# SUBDIVISION REPORT - CONCEPT/DEVELOPMENT PLAN

▶ **FILE #:** 7-SD-26-C  
7-D-26-DP

▶ **SUBDIVISION:** 7716 STRAWBERRY PLAINS PIKE  
▶ **APPLICANT/DEVELOPER:** 7716 STRAWBERRY PLAINS PIKE  
**OWNER(S):** Amy Elizabeth Nail

# CONCEPT PLAN

SHEET C-5

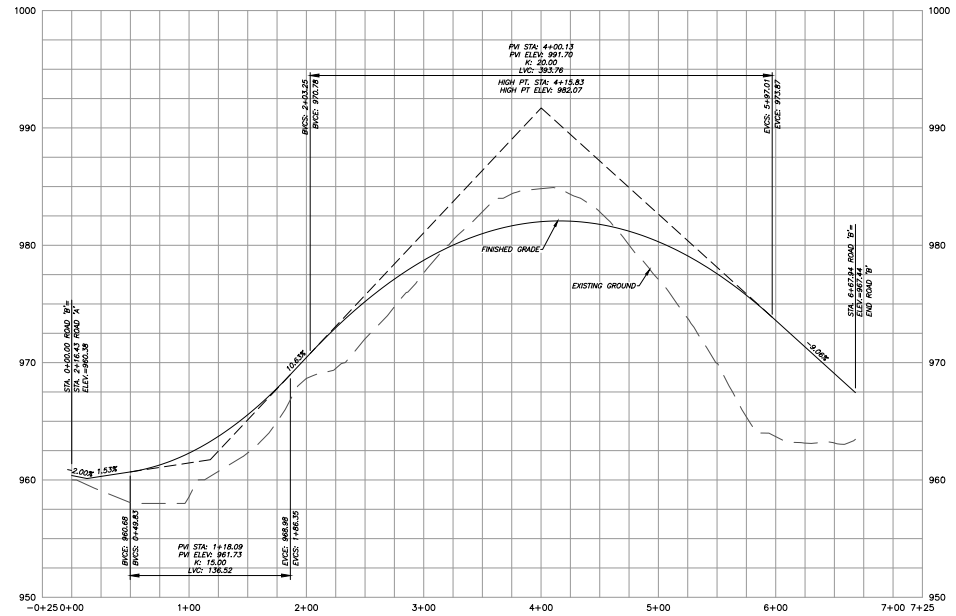
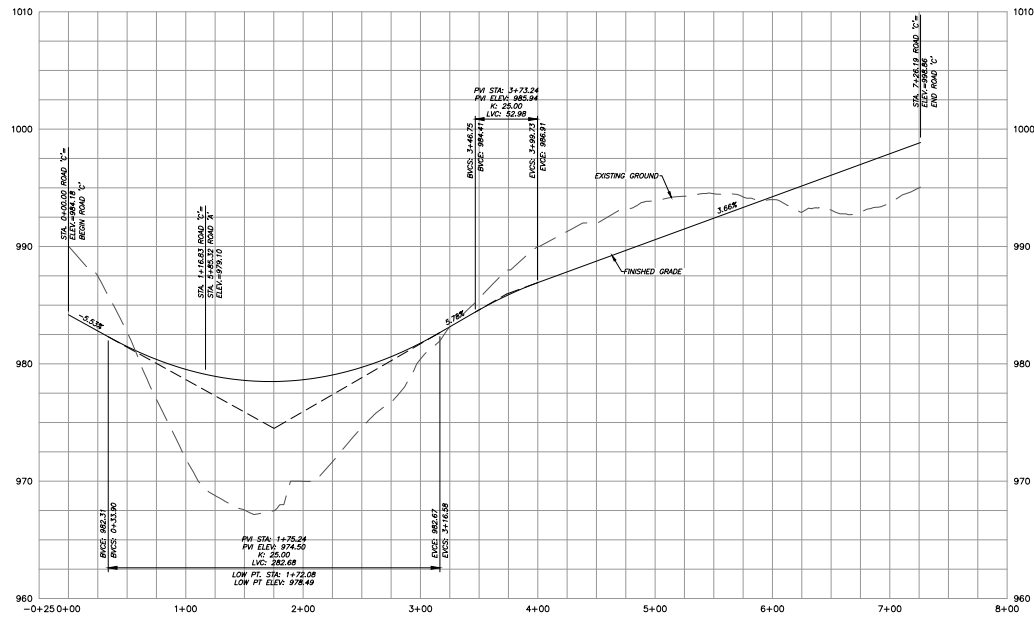
▶ **SUBDIVISION VARIANCES REQUIRED:** **VARIANCES**  
1. Reduce the K value from 25 to 20 at station 4+00.13 on Road B.  
2. Reduce the tangent distance between reverse curves from 50 ft to 17.24 at station 3+50.16 on Road A.

- **Approve the variance to reduce the K value from 25 to 20 at STA 4+00.13 on Road B.**
- A. Due to the existing steeper topography along Road B, a reduction of the vertical curve length is needed to keep site grading balanced.
  - B. The topography and shape of the property are unique and have not been created by any person having an interest in the property.
  - C. The proposed K value meets the American Association of State Highway and Transportation Officials requirements. Knox County Engineering and Public Works recommends approval of this variance based on the justifications provided by the applicant.

**Approve the variance to reduce the tangent length between reverse curves on Road A from 50 ft to 17.23 ft from STA 3+50.16 to 3+67.39.**

- A. Due to the steeper topography along Road A, the shortened tangent will allow the road to more effectively follow existing topography.
- B. The topography and shape of the property are unique and have not been created by any person having an interest in the property.
- C. This is a road with low traffic volumes, and the variation is not great enough to cause detriment to public safety, health, or welfare, nor would it be injurious to other properties in the neighborhood. Knox County Engineering and Public Works recommends approval of this variance based on the justifications provided by the applicant.

EXHIBIT C

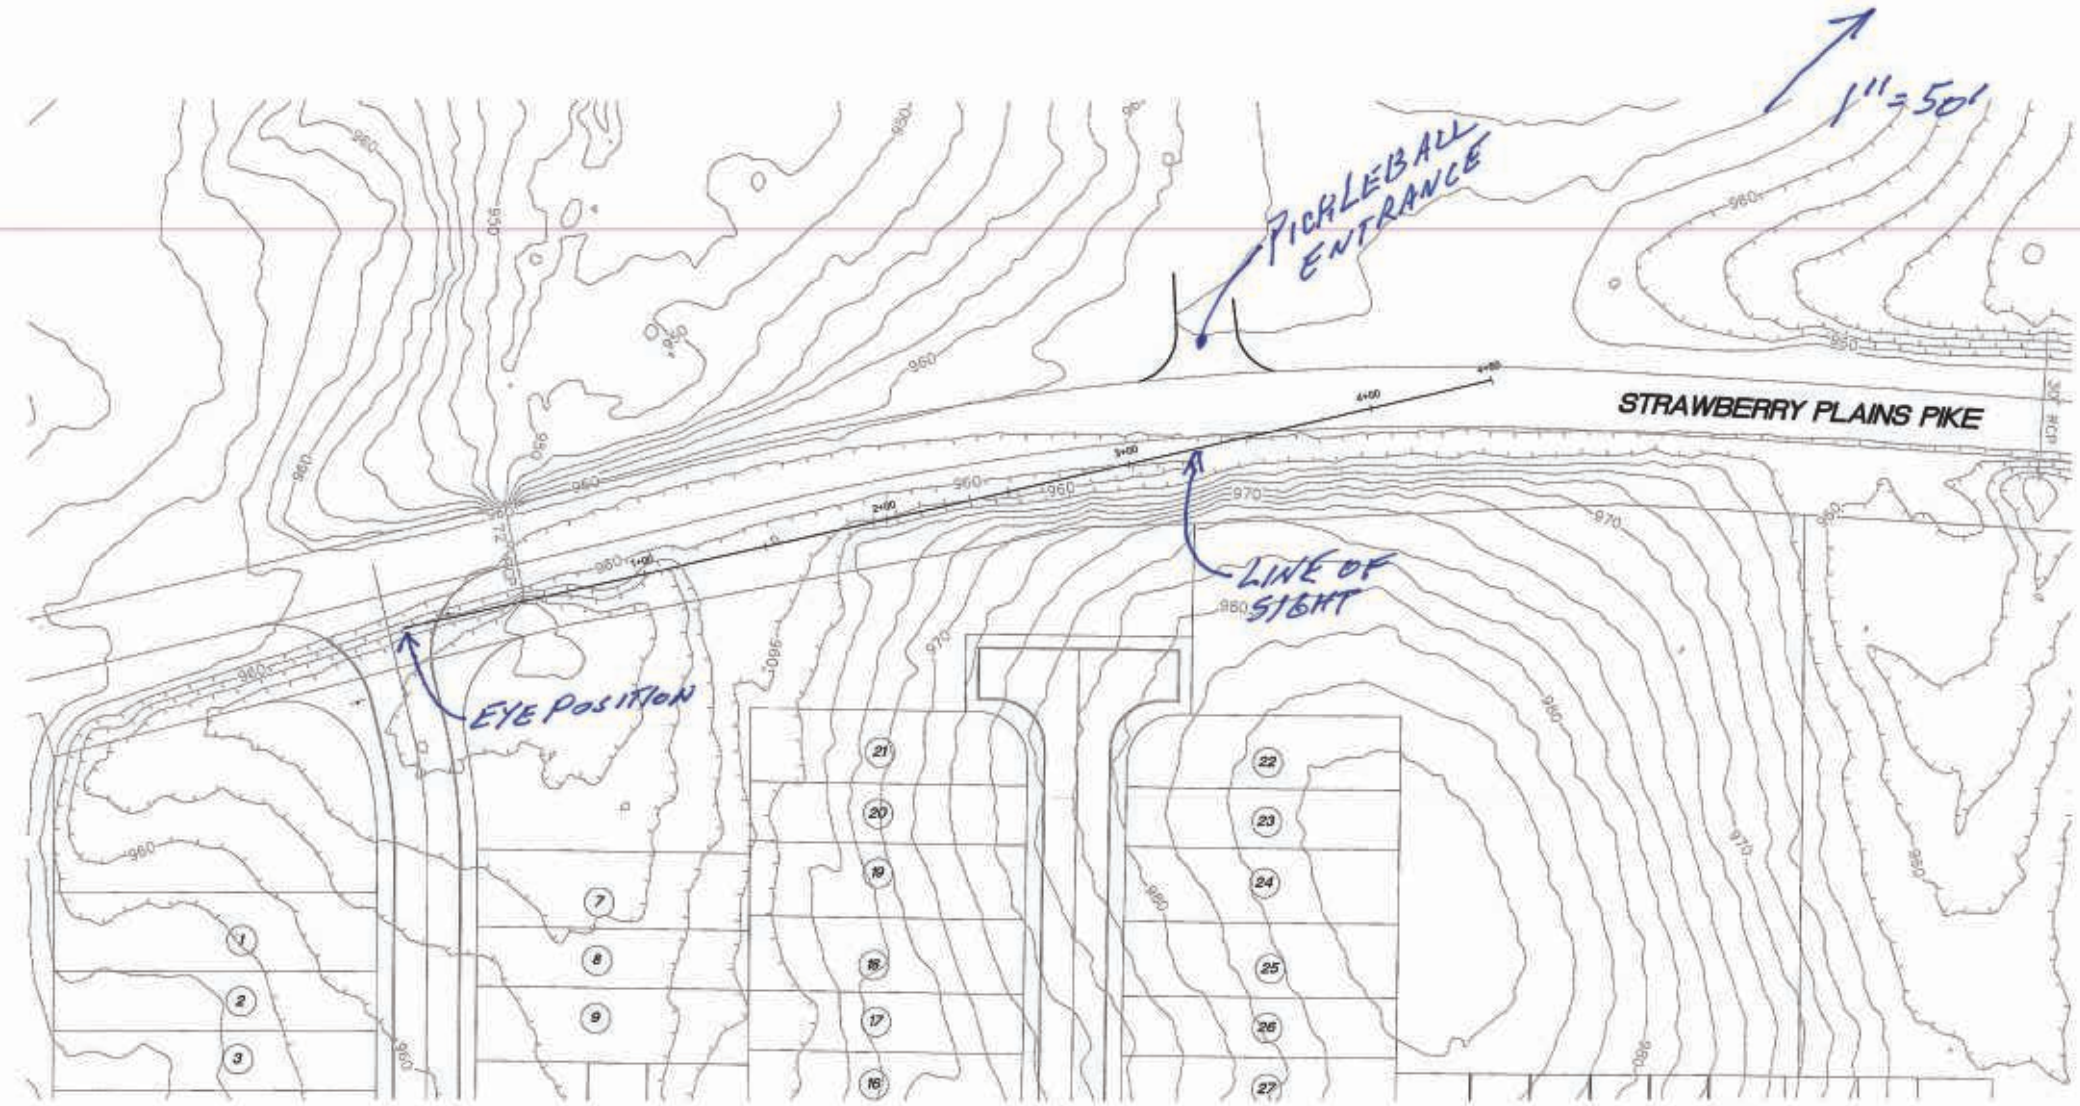
5. Certifying that the required sight distance is available along Strawberry Plains Pike in both directions at the Road 'A' intersection, with documentation provided to Knox County Engineering and Public Works for review and approval during the design plan phase.

Sight distance was evaluated to the east and west of the proposed ingress / egress location at 7716 Strawberry Plains Pike. The sight distance was measured at 15 feet from the edge of the roadway in both directions along Strawberry Plains Pike. The posted speed is 45 MPH. Per Knox County Subdivision Regulations, the required sight distance is 450'.

There is approximately 700' of available sight distance facing west.

Facing east, the sight distance is in excess of 450'. There are no vertical obstructions. Vegetation removal may be necessary. The extent of the potential vegetation removal will be evaluated during permitting or construction.
